July 17, 2007 CPC

STAFF'S
REQUEST ANALYSIS
AND
RECOMMENDATION

06TS0211

Patrick Construction
Autumn Grove (Formerly Autumn Leaf)

06TS0211
AUTUMN GROVE

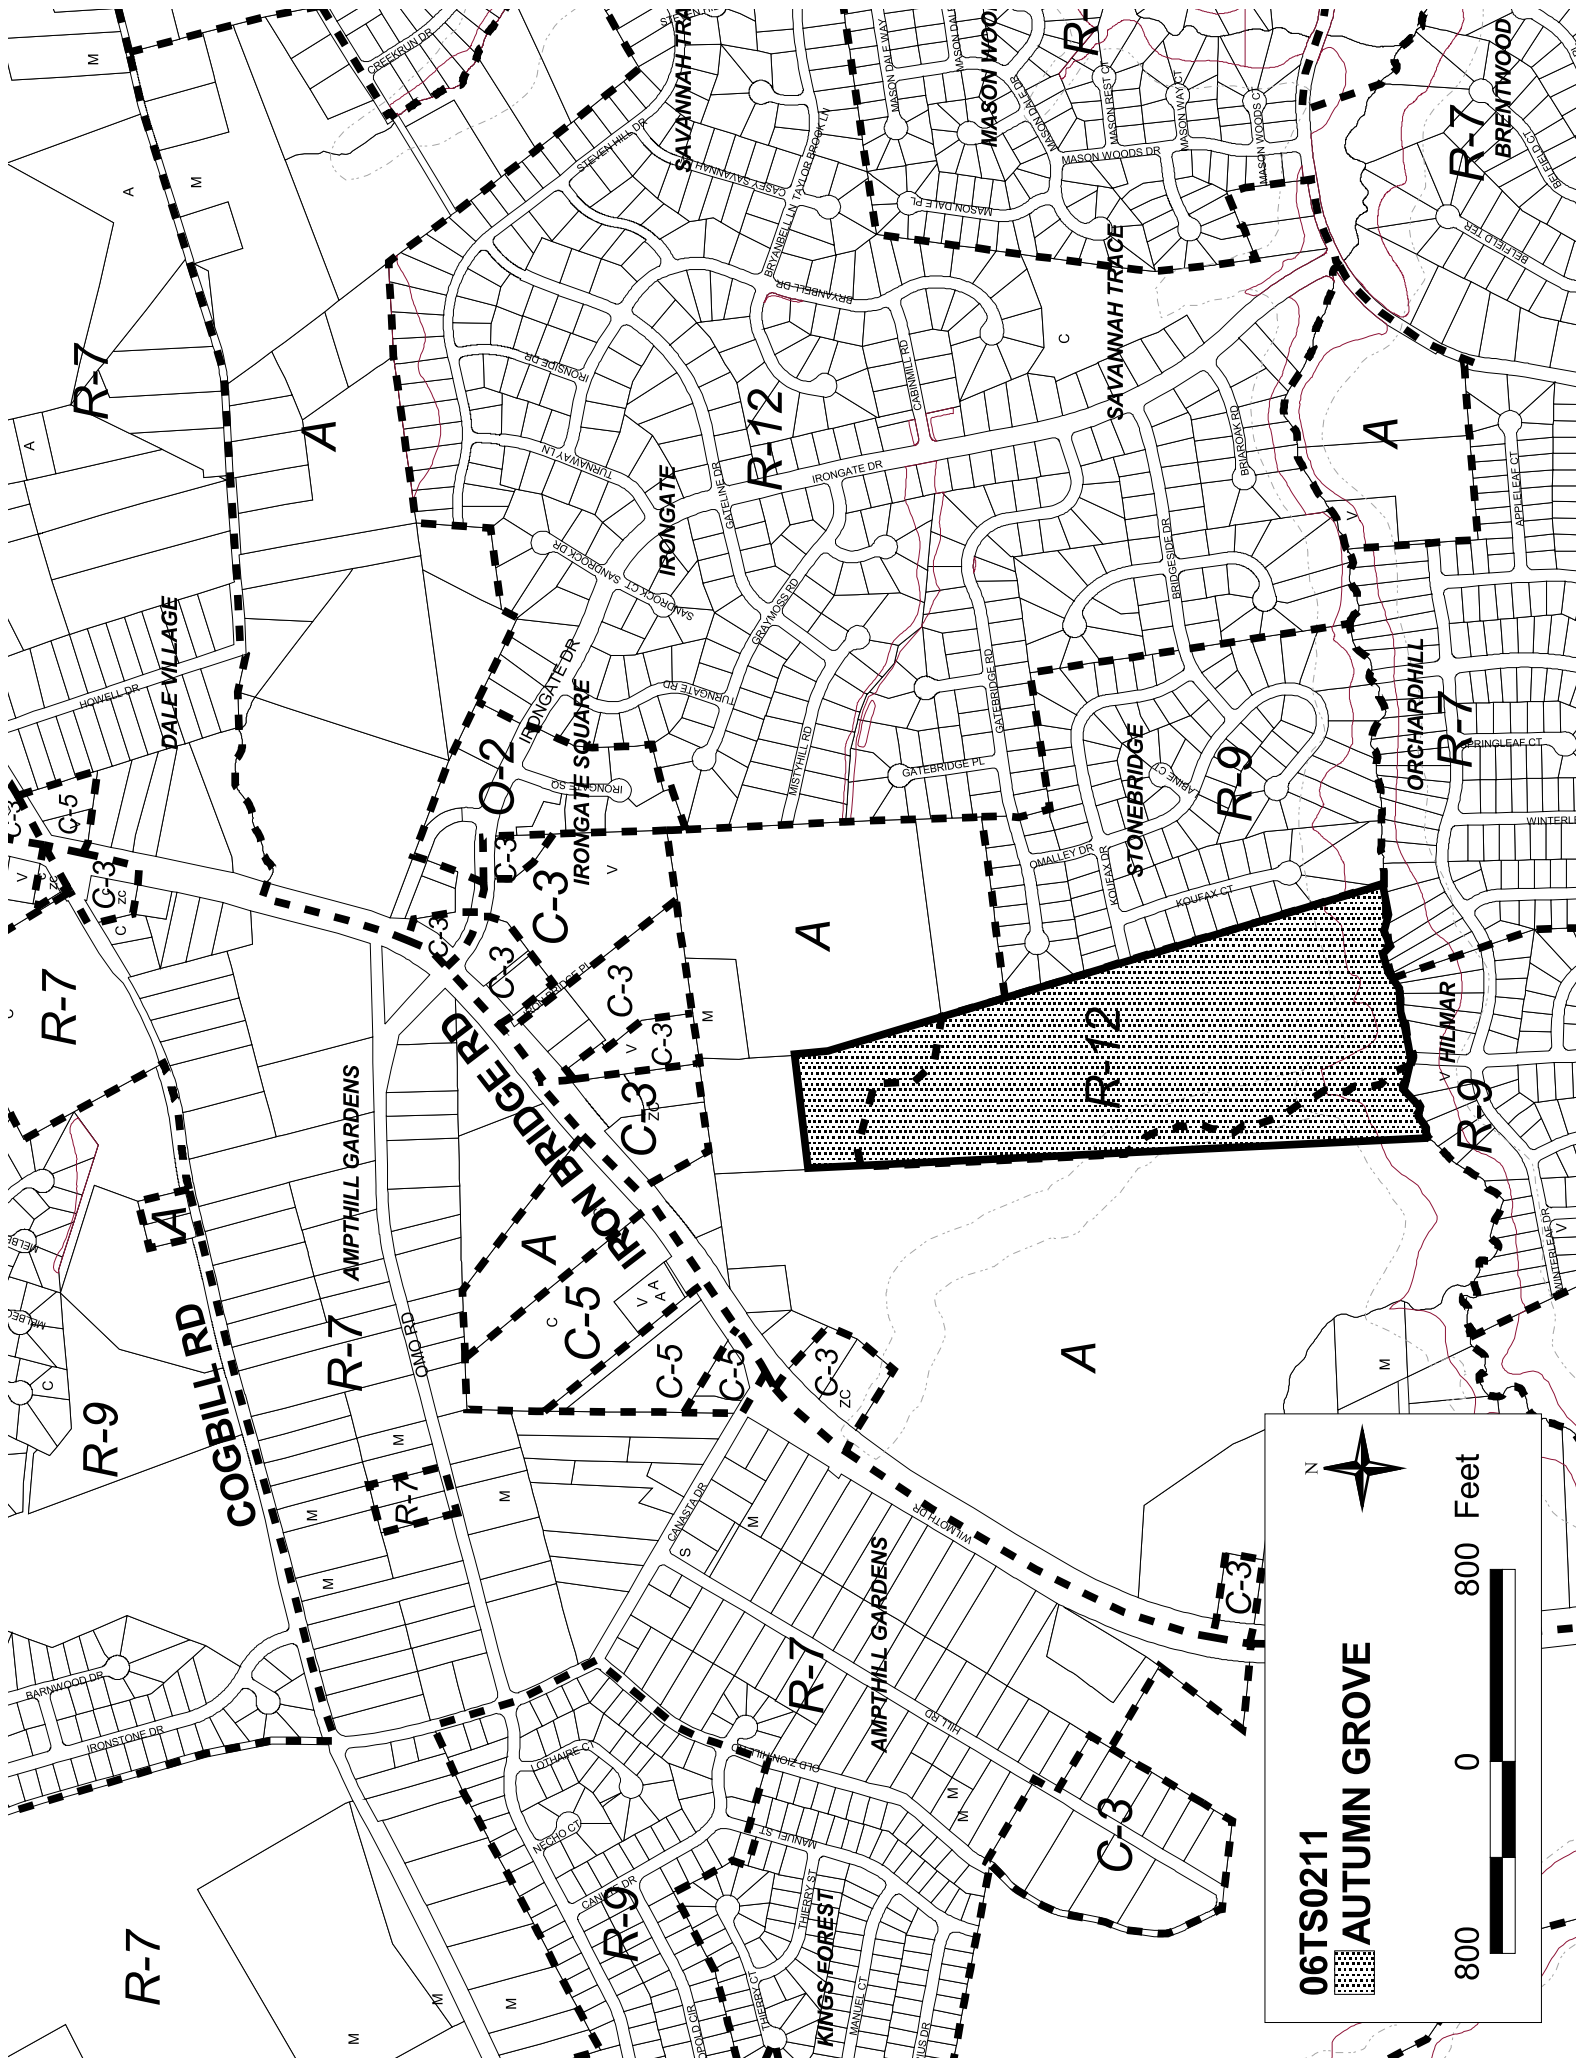
REQUEST: The applicant requests approval of a tentative subdivision plat with seventy-eight (78) lots that requires an exception to Section 17-76 (h) of the Subdivision Ordinance regarding second street access requirements for lots in excess of fifty (50).

Staff recommends denial of the tentative request as submitted for the following reasons:

- A. The tentative subdivision conforms to the provisions of the Subdivision Ordinance, with the exception to the street access requirement of fifty (50) lots or less on one (1) access.
- B. The Fire Department has consistently not supported access to more than fifty (50) lots on a single access for safety reasons.

The Fire Department continues to support a second street, providing access to all lots constructed prior to, or in conjunction with, the recordation of the fifty-first lot or the maximum approved by the Board of Supervisors.

If this application is approved, up to 102 lots would have sole access through the intersection of Omalley Drive and Koufax Drive in an easterly direction. The Fire Department could experience limited access in an emergency situation. (Attachment 3)
